UNITED STATES PATENT AND TRADEMARK OFFICE

APPLICATION NO.	FILING DATE	FIRST NAMED INVENTOR	ATTORNEY DOCKET NO.	CONFIRMATION NO.
10/655,854	09/05/2003	Rafael Reif	MIT-136AUS	7254
22494	7590	05/10/2007	EXAMINER	
DALY, CROWLEY, MOFFORD & DURKEE, LLP			ANDUJAR, LEONARDO	
SUITE 301A			ART UNIT	PAPER NUMBER
354A TURNPIKE STREET			2826	
CANTON, MA 02021-2714				
MAIL DATE		DELIVERY MODE		
05/10/2007		PAPER

Office Action Summary	Application No.	Applicant(s)
	10/655,854	REIF ET AL.
	Examiner	Art Unit
	Leonardo Andújar	2826

DETAILED ACTION

FIG.1

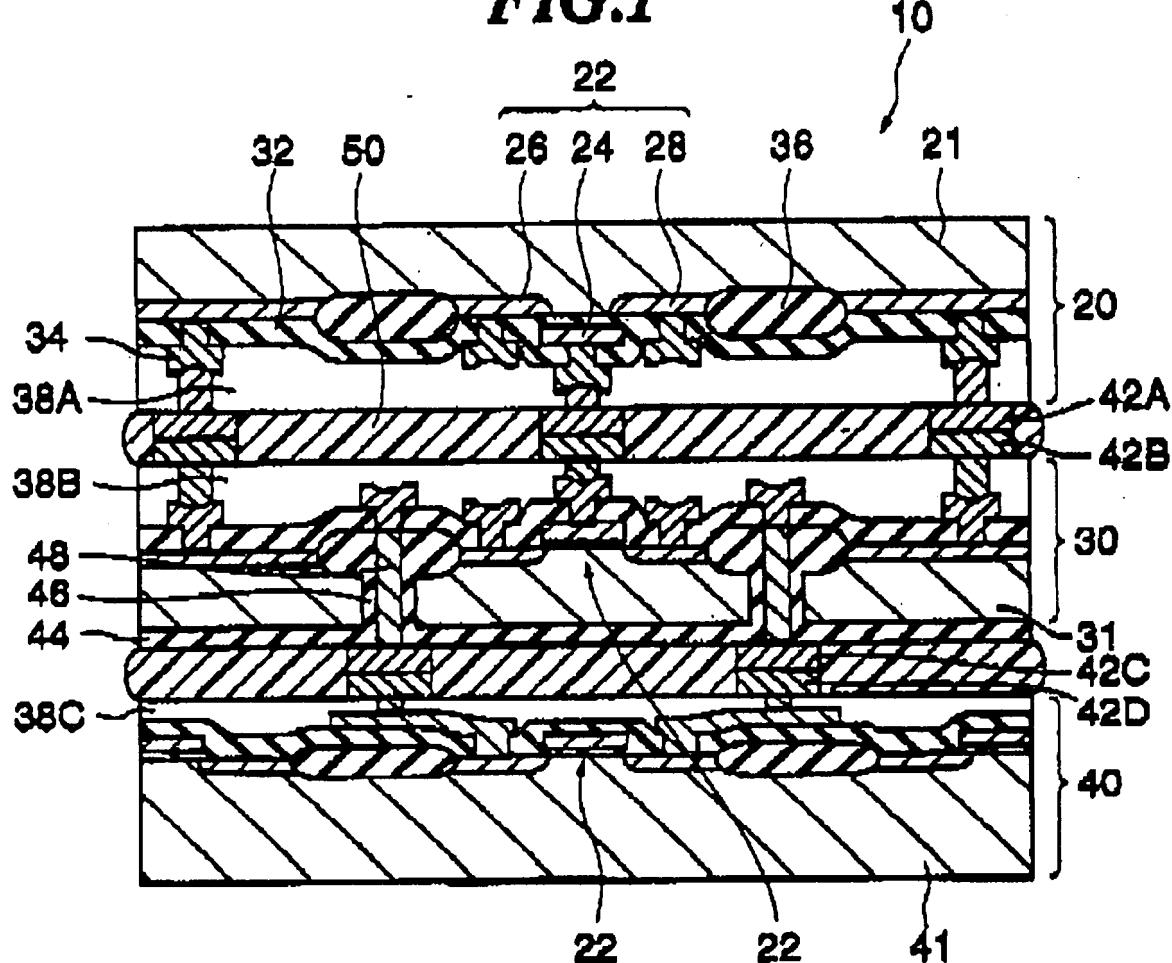
4. Regarding claims 1 and 17, Koyagani (e.g. figs. 1 & 5) shows a multi layer integrated semiconductor structure, comprising:

c) a first conductive interface 42 having a first surface and a second opposing surface with the first surface of the conductive interface disposed between at least a portion of a first one of the first and second opposing surfaces of the first device layer and at least a portion of a first one of the first and second opposing surfaces of the second device layers such that at least a portion of the first conductive interface secures together the first and second device layers and also electrically couples the first device layer to the second device layer wherein the conductive interface and the first and second conductive vias form at least a portion of an electrical communication path between the first device layer and the second device layer (see also fig. 5).

5. Regarding claim 2, Koyanagi shows a first conductive interconnect element 34b disposed in the dielectric material of the first device layer with a first end of the conductive interconnect element coupled to the first conductive via and a second end of the first conductive interconnect element coupled to at least one of the first plurality of doped semiconductor elements.
6. Regarding claim 4, Koyanagi shows a second conductive interconnect 34c having a first portion disposed over at least a portion of one of the second plurality of

11. Regarding claim 10, Koyanagi shows a third conductive via 34b provided in the first device layer, wherein the third conductive via is coupled between a portion of the first conductive interconnect and the at least one of the first plurality of doped regions.

36. Regarding claim 40, Koyanagi (e.g. figs. 1 & 5) shows a multi-layer semiconductor structure, comprising: a first semiconductor wafer 40 having first and second opposing surfaces, the first semiconductor wafer including a first plurality of semiconductor structures each of which includes a first plurality of semiconductor elements 22, the first semiconductor wafer also comprising a first plurality of conductive vias 34b, at least some of the first plurality of conductive vias disposed such that a first end of thereof is electrically coupled to at least one of the first plurality of semiconductor elements and a second is exposed through one of the first and second surfaces of the first semiconductor wafer; a second semiconductor wafer 30 having first and second opposing surfaces, the second semiconductor wafer including a second plurality of semiconductor structures each of which includes a second plurality of semiconductor elements 22, the second semiconductor wafer also comprising a second plurality of conductive vias 48 disposed such that a first end of thereof is electrically coupled to at least some of the second plurality of second elements and a second end is exposed

42. Applicant's arguments with respect to claim 1, 2, 4-8 and 10-40 have been considered but they are not persuasive. Applicant argues that the prior art does not teach that the second device layer is secured to the first device via the conductive interface. It is respectfully noted that Koyagani shows that the interface 42's secure the first 40 and second device 30 (col. 10/lls. 37-46). Furthermore, the fact that epoxy is
